Written Representations submitted in response to East Pye Solar
PINS Reference: EN0110014
Volume 3: Chapters 11 – 20

Submitted by BEPS (Block East Pye Solar [redacted])

11.16.1 The application contains an unresolved discrepancy in the number of affected PRoWs

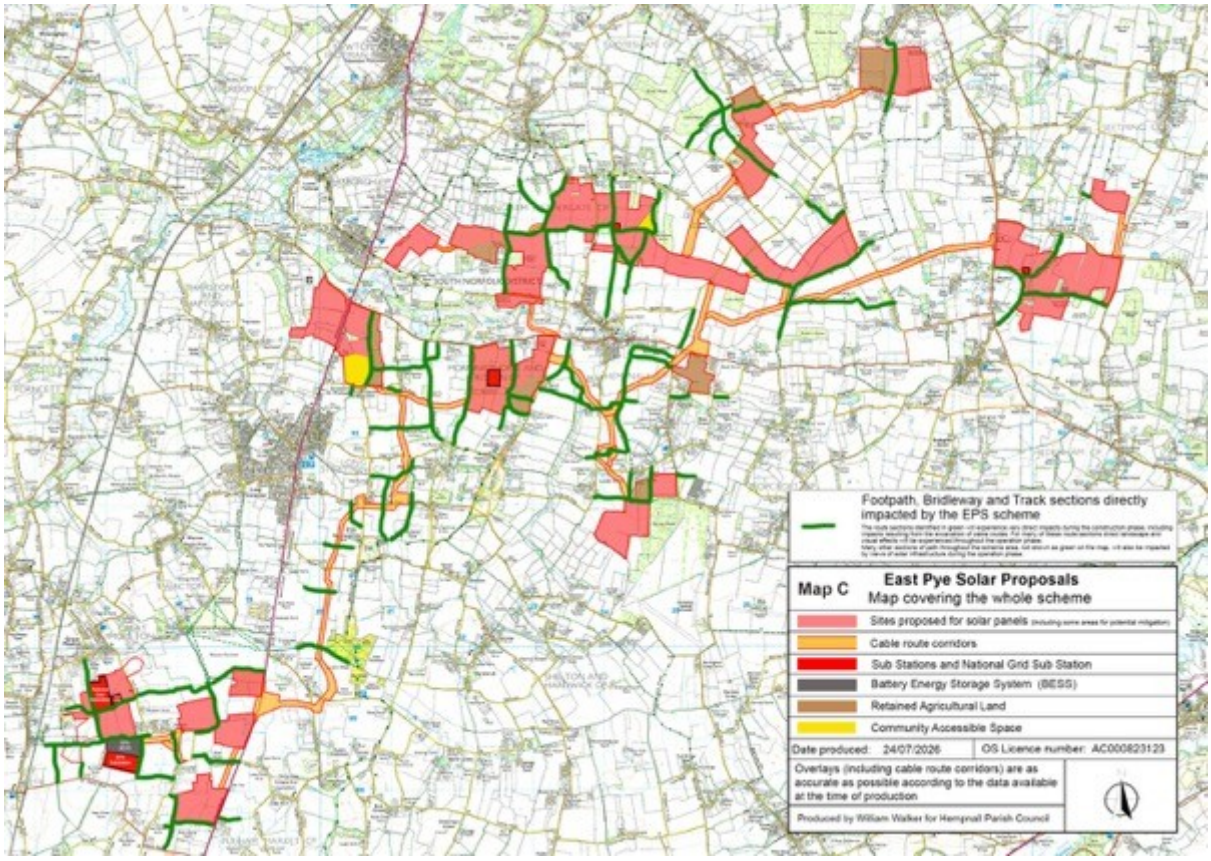
The Outline PRoW material refers to 84 PRoWs, while the Applicant's consultation record with NCC identifies 88 routes: 75 footpaths, 11 restricted byways and two bridleways.

That discrepancy requires explanation. It is not a trivial numerical issue because the affected network determines:
